Project	IEEE 802.16 Broadband Wireless Access Working Group < http://ieee802.org/16 >
Title	Fix broken message flow in HO decision & initiation
Date Submitted	2005-07-18
Source(s)	David Xiang, Phillip Barber, Jim Carlo, Duke Dang, Lucy Chen, John Lee, mailto: dxiang@futurewei.com HUAWEI Mary Chion, Sean Cai ZTE San Diego Mo-Han Fong Nortel
Re:	Call for contribution and comments.
Abstract	Fix broken message flow in HO decision & initiation
Purpose	Adoption
Notice	This document has been prepared to assist IEEE 802.16. It is offered as a basis for discussion and is not binding on the contributing individual(s) or organization(s). The material in this document is subject to change in form and content after further study. The contributor(s) reserve(s) the right to add, amend or withdraw material contained herein.
Release	The contributor grants a free, irrevocable license to the IEEE to incorporate material contained in this contribution, and any modifications thereof, in the creation of an IEEE Standards publication; to copyright in the IEEE's name any IEEE Standards publication even though it may include portions of this contribution; and at the IEEE's sole discretion to permit others

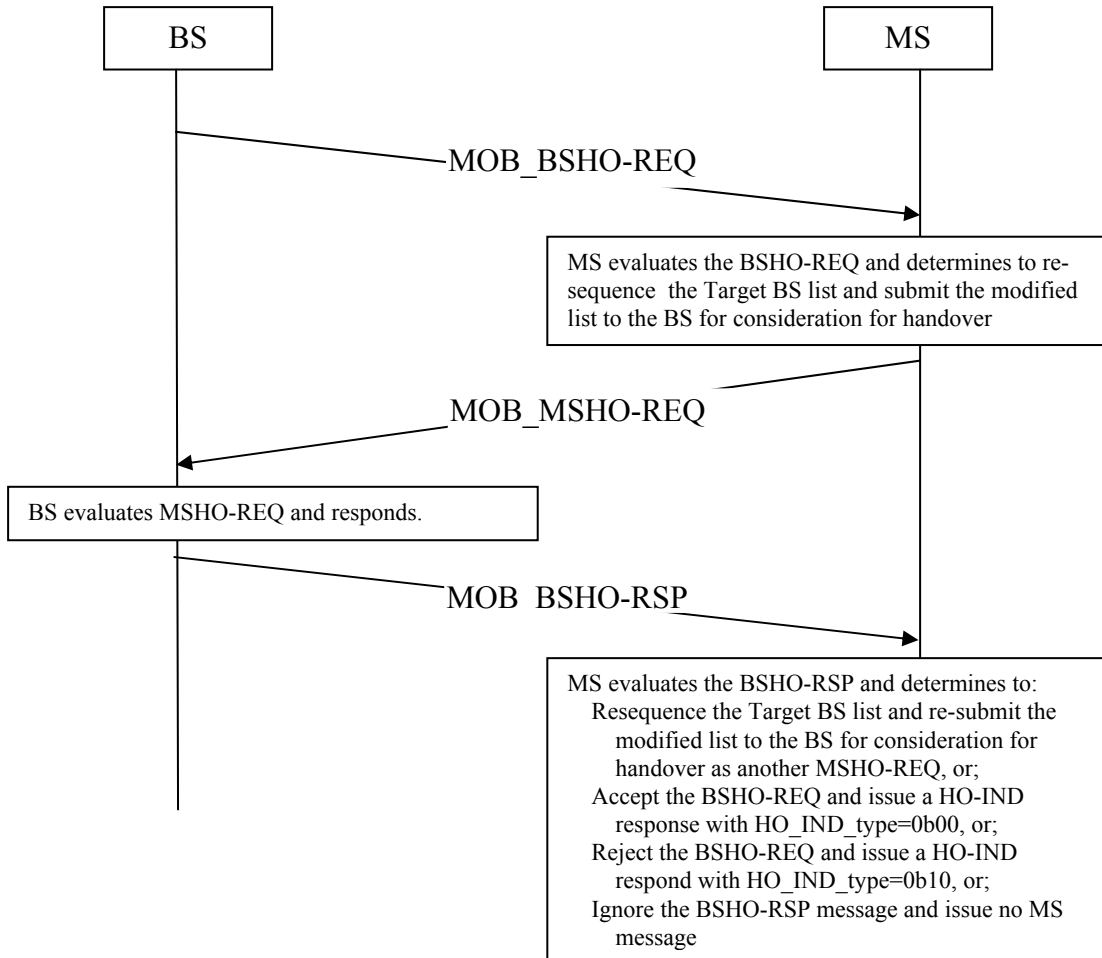
The change of the message (in bold in the text) from MOB_BSHO-REQ to MOB_MSHO-REQ has disastrous results as can be seen in the following diagram.

According to the revised language in D8 (and carried forward in D9), the BS will ignore any MSHO-REQ following a BSHO-REQ. So MS loses the ability to respond to a BSHO-REQ by modifying the selection and submitting a revised selection via a MSHO-REQ. I am sure that this change was made originally to express BS precedence in concurrent MSHO-REQ/BSHO-REQ transmissions. Of course that decision was in error since

there is no requirement that MS even respond to BSHO-REQ or BSHO-RSP, but there is requirement that BS respond to MSHO-REQ. So perception of precedence is really irrelevant. MS messaging is, in fact, independent of BS handover messaging, even if MS uses information obtained from the BS handover messages to construct MS handover messages.

Revert language in 6.3.21.2.2 HO decision & initiation, page 178, paragraph 2 back to original text.

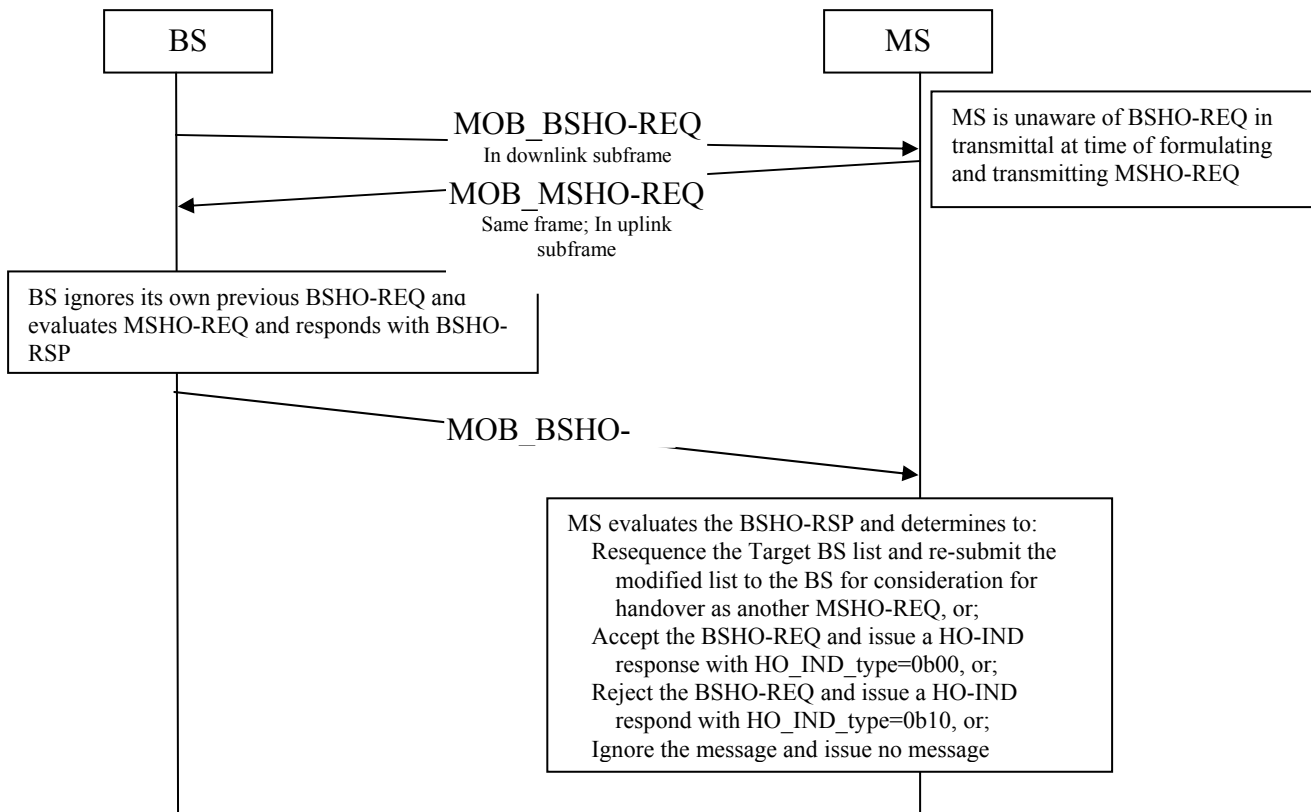
Changing the instance back to BSHO-REQ does not create a problem as the following diagrams demonstrate:

The figure above shows the normal function of the messaging when the race condition constraint is reinstated as BSHO-REQ in place of MSHO-REQ. Note that this was the intended sequence and performance.

The figure above shows same frame transmission (concurrent transmission) of mutual HO-REQ messages. Note that even in this instance, due to the subdivision of the frame into downlink and uplink subframes, the BSHO-REQ always occurs first in time in concurrent transmission. As is shown in the figure, message flow works normally when the race condition constraint is reinstated as BSHO-REQ in place of MSHO-REQ.

In summary, reversion to BSHO-REQ from MSHO-REQ in the condition constraint repairs the message flow to proper function and does not injure performance in any race condition.
